Access Compliance Report Public Rights-of-Way (Curb Ramps)

Main Street: SIENNA_PKWY		Cross Street: MAIN_ST		Location:	NW
--------------------------	--	-----------------------	--	-----------	----

ADA ID: RPRK211022124056	Ramp Type: Type 4 - Parallel	Initial Pass/Fail: Fail	Overall Compliance: No	Severity Score:	45
--------------------------	------------------------------	-------------------------	------------------------	-----------------	----

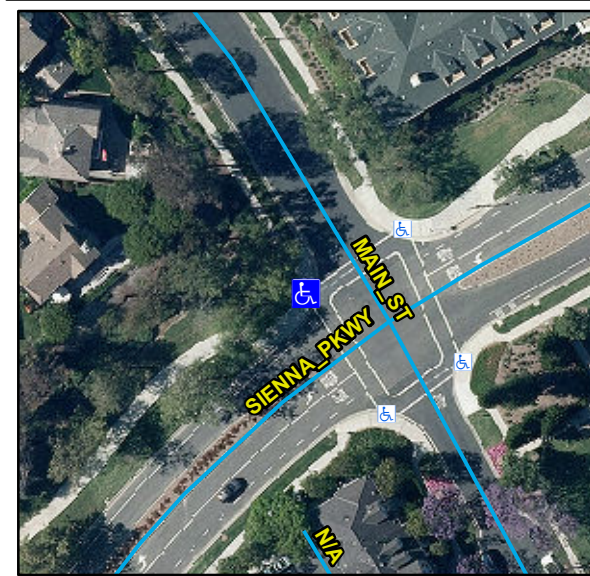
Compliance	Description	Data	Compliance	Description	Data
N/A	Ramp Length LT (in)	110	N/A	Ramp Length RT (in)	115
Yes	Ramp Width LT (in)	90	Yes	Ramp Width RT (in)	90
Yes	Ramp Run Slope LT (%)	0.7	No	Ramp Run Slope RT (%)	9
No	Ramp Cross Slope LT (%)	6.9	No	Ramp Cross Slope RT (%)	8.6
N/A	Landing Present	N/A	N/A	DWS Provided	N/A
N/A	Landing Length (in)	N/A	N/A	DWS Contrast	N/A
N/A	Landing Width (in)	N/A	N/A	DWS Length (in)	N/A
N/A	Landing Run Slope (%)	N/A	N/A	DWS Full Width	N/A
N/A	Landing Cross Slope (%)	N/A		DWS Offset Type	N/A
N/A	Landing Movement Obstructed?	N/A	N/A	DWS Offset Left (in)	N/A
	Landing Movement Type	N/A	N/A	DWS Offset Right (in)	N/A
N/A	Landing Shared	N/A			
N/A	Clear Space	Yes			
N/A	Clear Space To Crosswalk (in)	48			
N/A	Marked Crosswalk 1	Yes	N/A	Marked Crosswalk 2	Yes
	Crossing 1 Direction	S		Crossing 2 Direction	E
	Marked Crosswalk 1 Width (in)	90		Marked Crosswalk 2 Width (in)	90
N/A	Ramp Inside Crosswalk 1	Yes	N/A	Ramp Inside Crosswalk 2	Yes

Possible Solutions:	
Remove & Replace Curb Ramp With Two New Directional Ramps or Equivalent.	
Surveyor Notes:	
N/A	
OC Std/PROW:	
R204.3, R304.5.3, R304.3.2, STD 1115	
Total Cost:	\$ 4000
